PREPARED FOR THE URBAN DESIGN COMMISSION AND PLAN COMMISSION

Project Address: 516-530 Cottage Grove Road
Application Type: Conditional Use
Legistar File ID #: [35558](#)
Prepared By: Heather Stouder, AICP, Planning Division
Report Includes Comments from other City Agencies, as noted

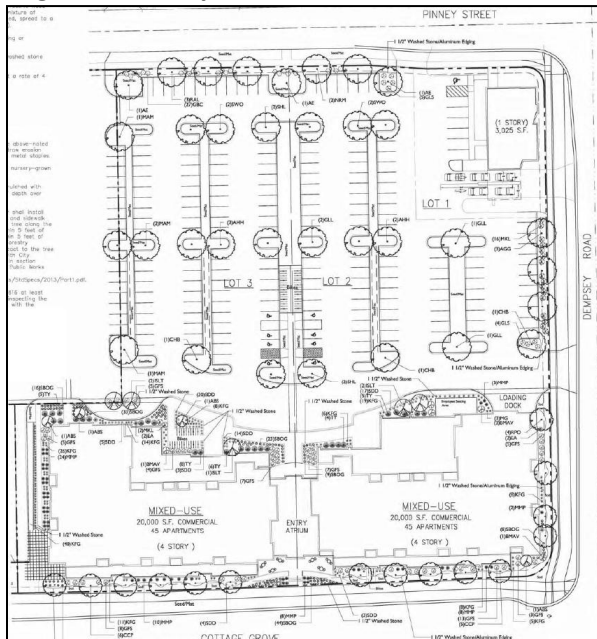
Parking and Circulation- The revised proposal has 185 surface parking stalls for automobiles, while the original submittal had 190. This slight reduction is the result of straightening out the drive aisle closest to the building and providing more space on the north side of the building for bicycle parking, landscaping, and gathering.

February 5, 2015 Landscape Plan

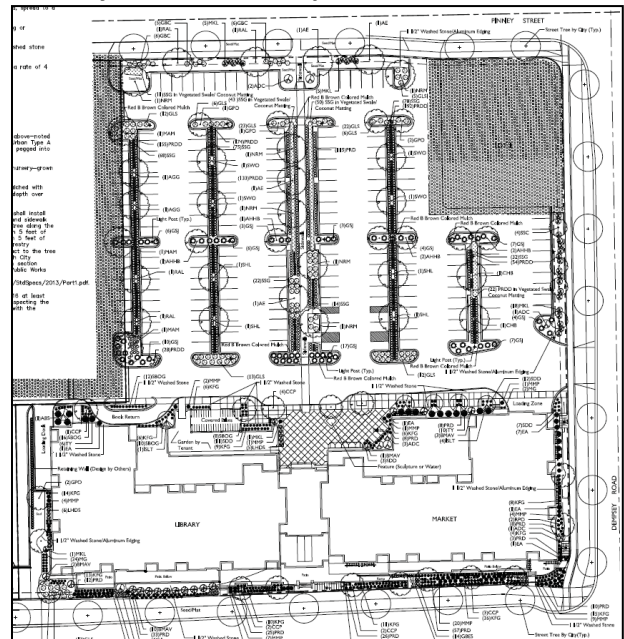
Landscaping and Other Site Details- The revised landscape plan provides for a better overall tree distribution in the surface parking area, and a significant increase in lower-level plantings (small trees, shrubs, and perennial grasses) in the landscaped areas between the parking rows. Landscaping near the building is similar, but a new garden area for the library space is provided, and there is a larger pedestrian space near the northern entrance to the building. On the whole, the landscaping points for the site have increased by over 20%.
